# **TUALATIN ARCHITECTURAL REVIEW BOARD**

June 10, 2015, 6:30 PM POLICE TRAINING ROOM 8650 SW TUALATIN RD TUALATIN, OR 97062

- A. Koch Manufacturing Expansion Project Recommendation and Staff Report for AR-15-05.
- 5. **COMMUNICATIONS FROM BOARD MEMBERS**
- 6. **ADJOURNMENT**

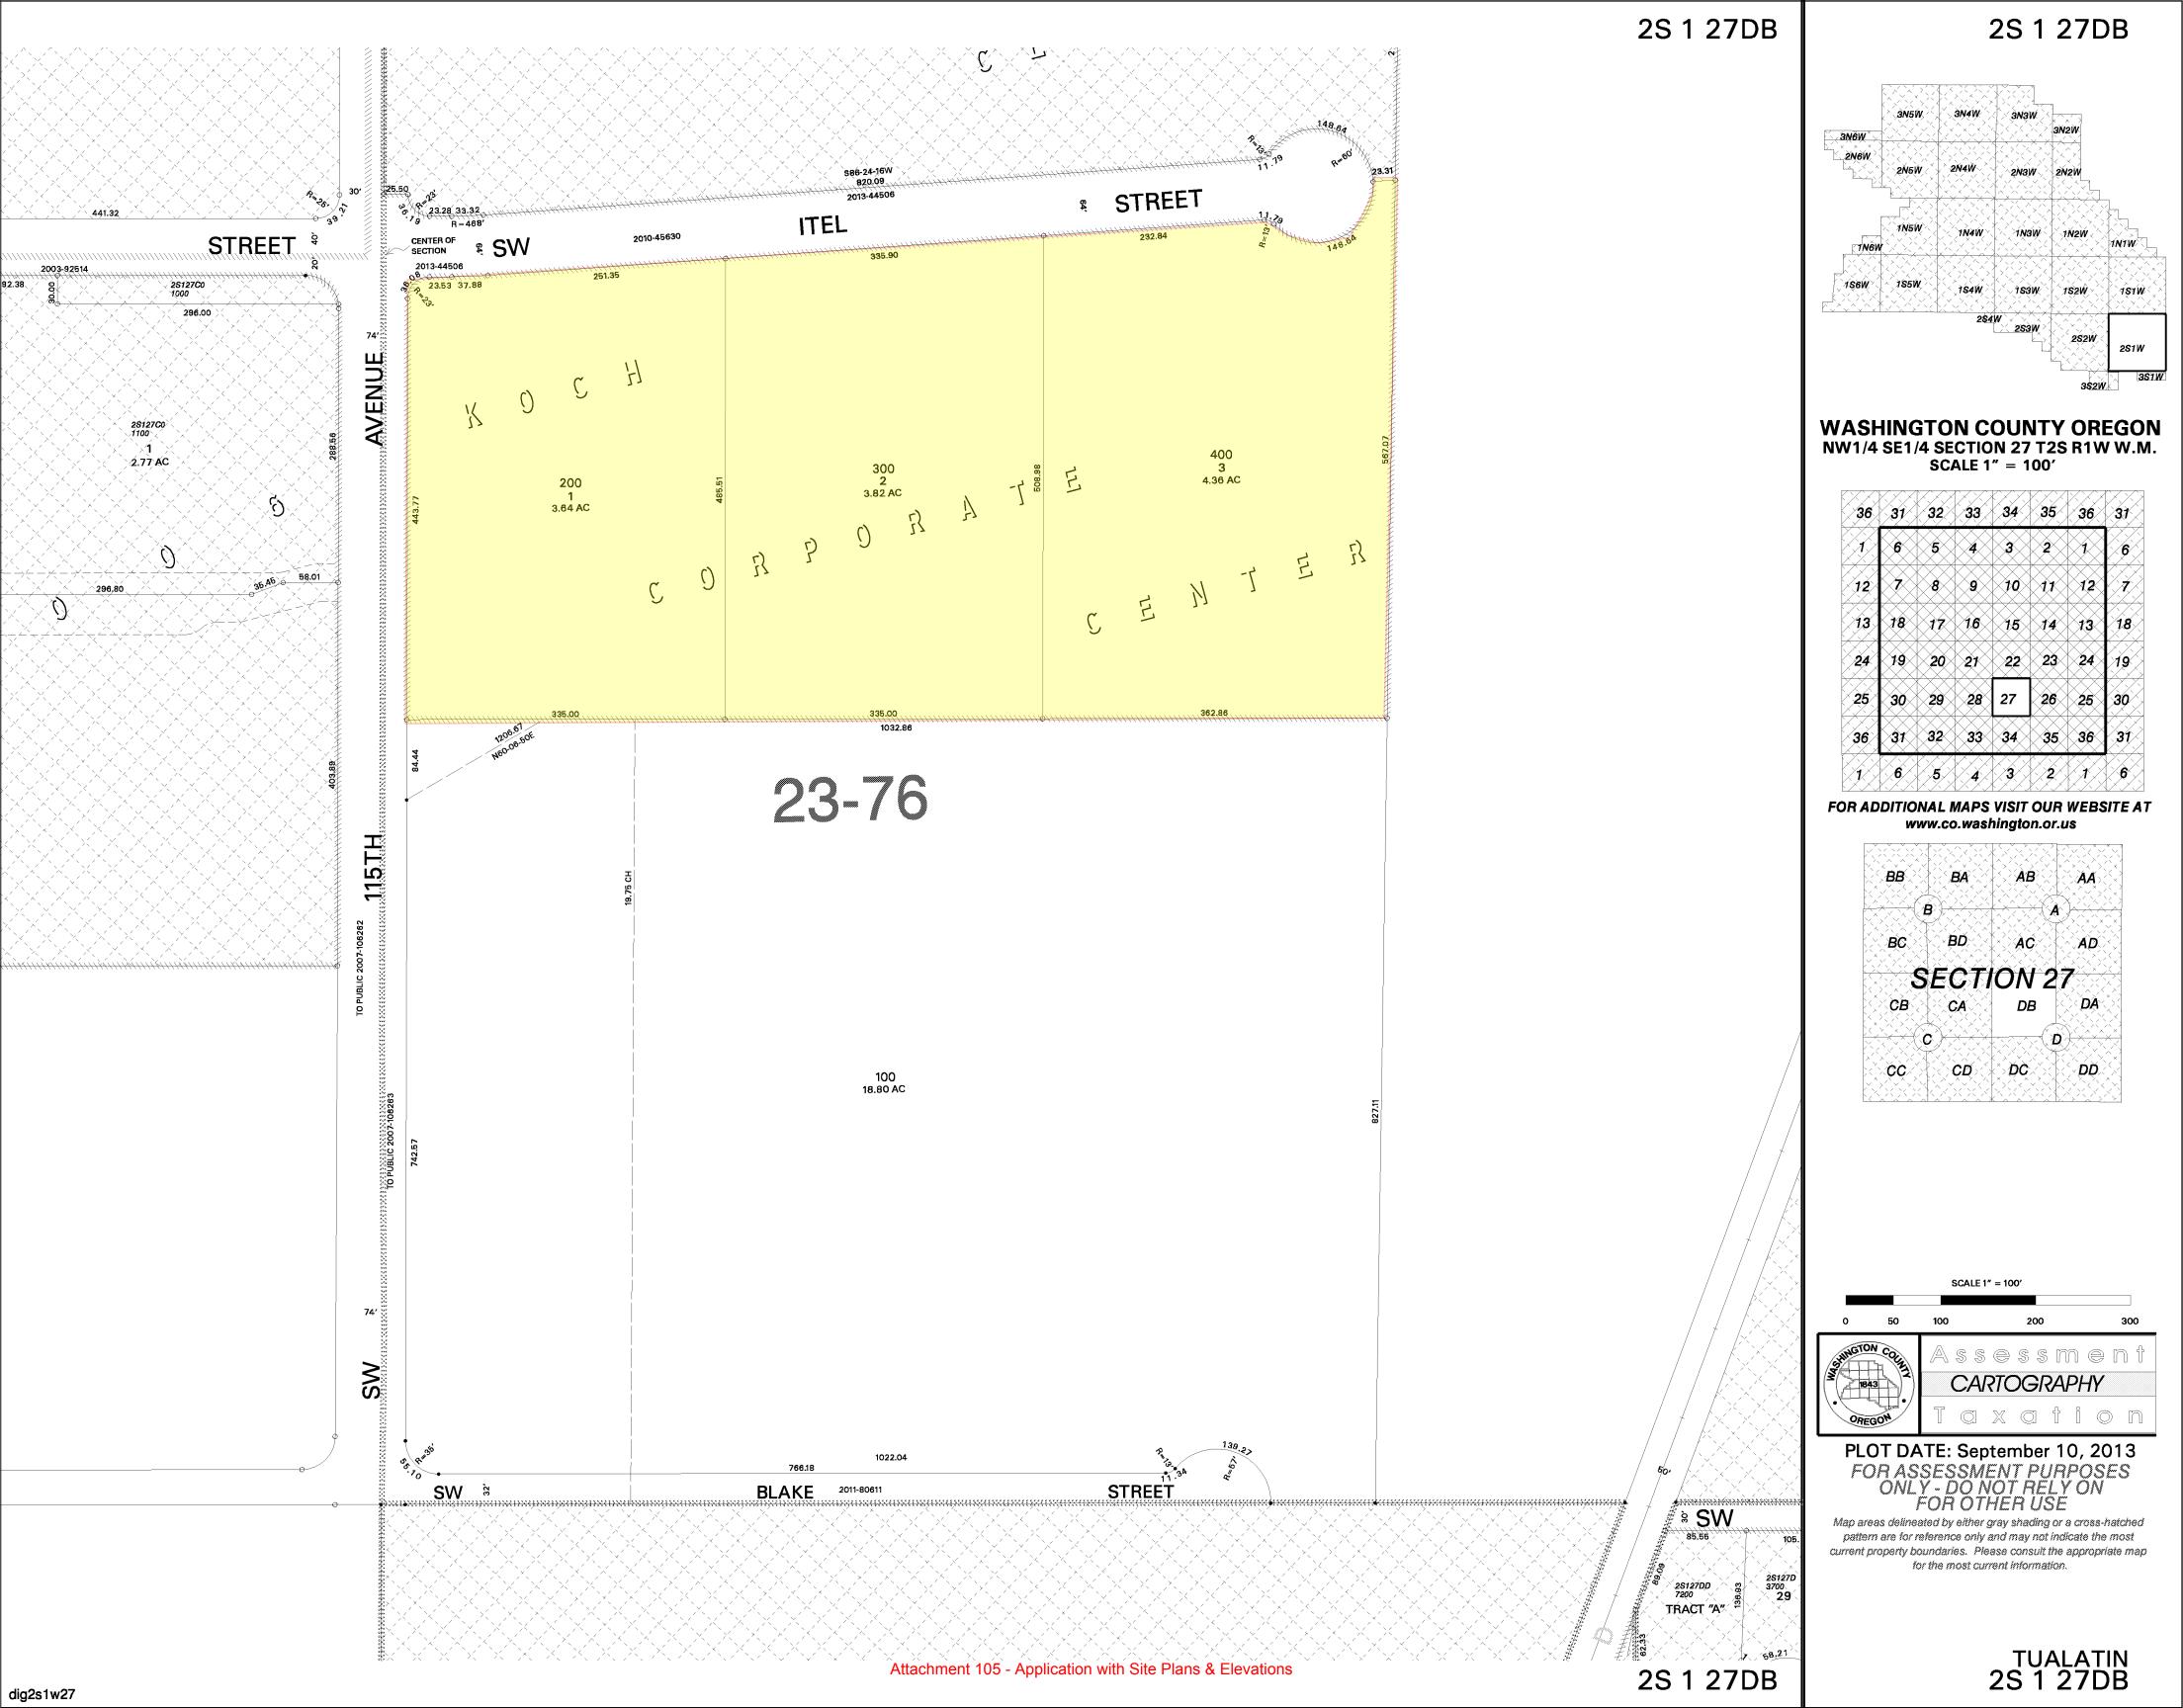
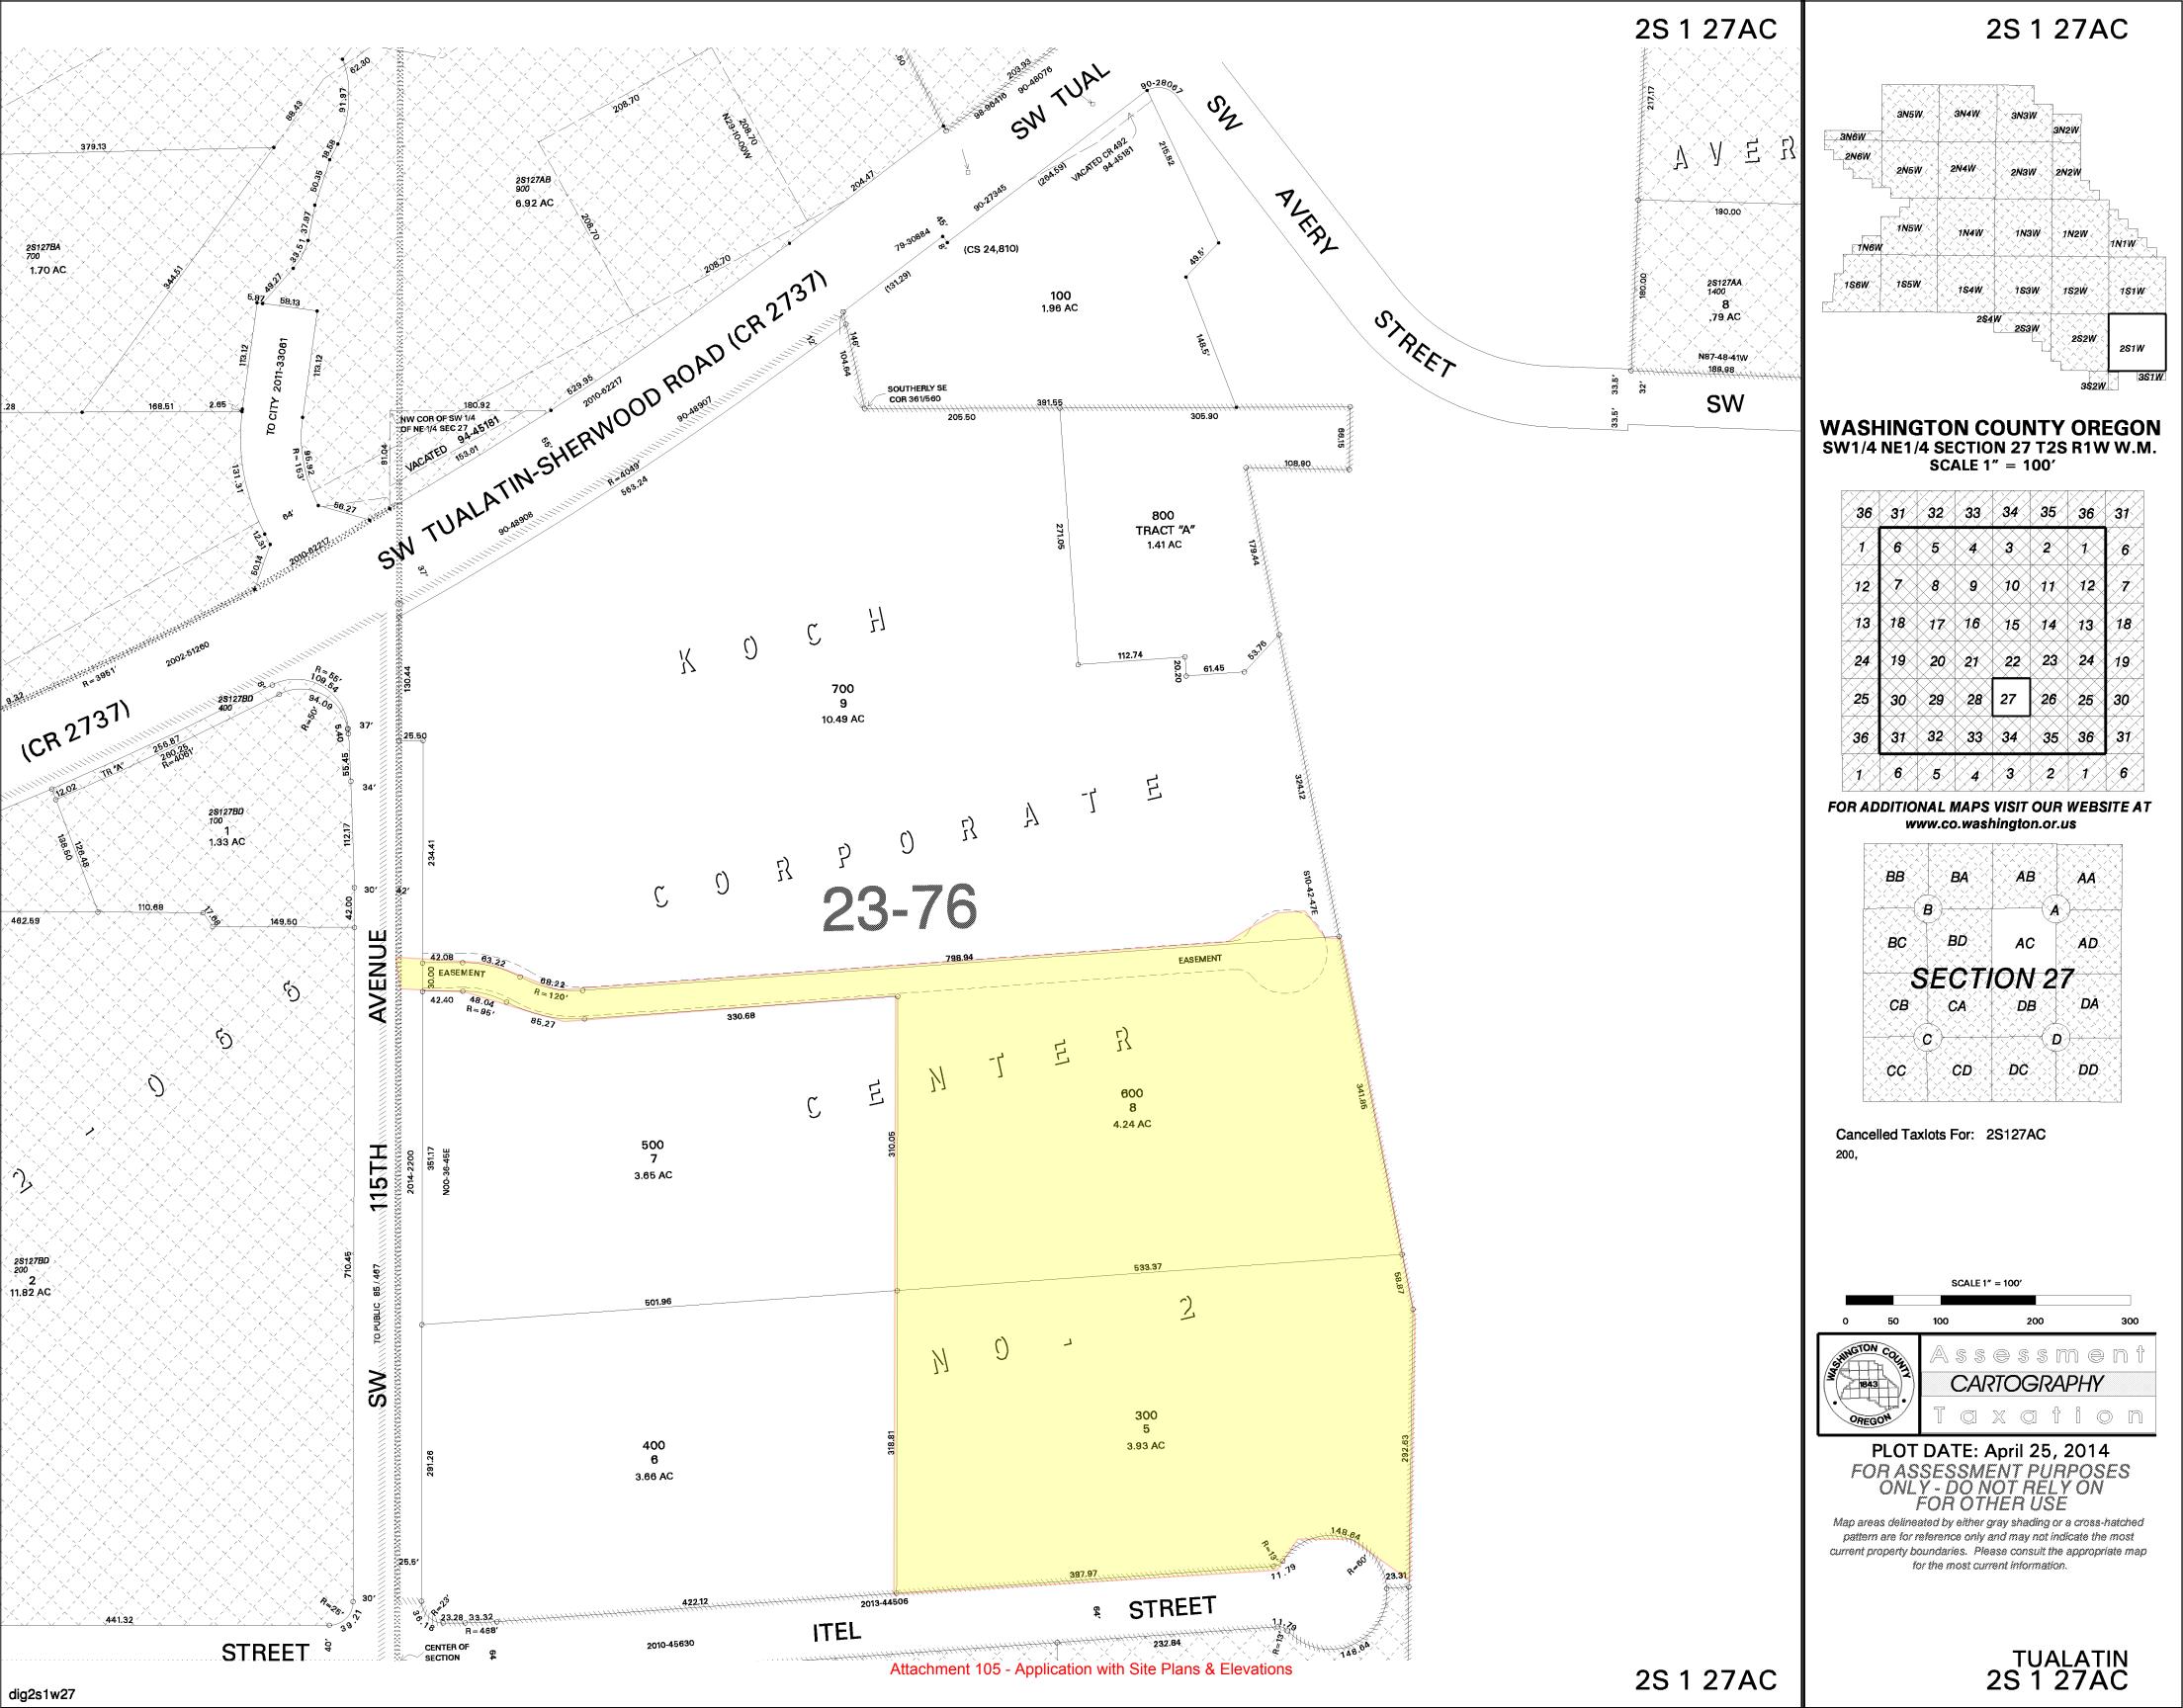
It looks like the locations of the enclosures, and size of the enclosures will be fine for us to service them.
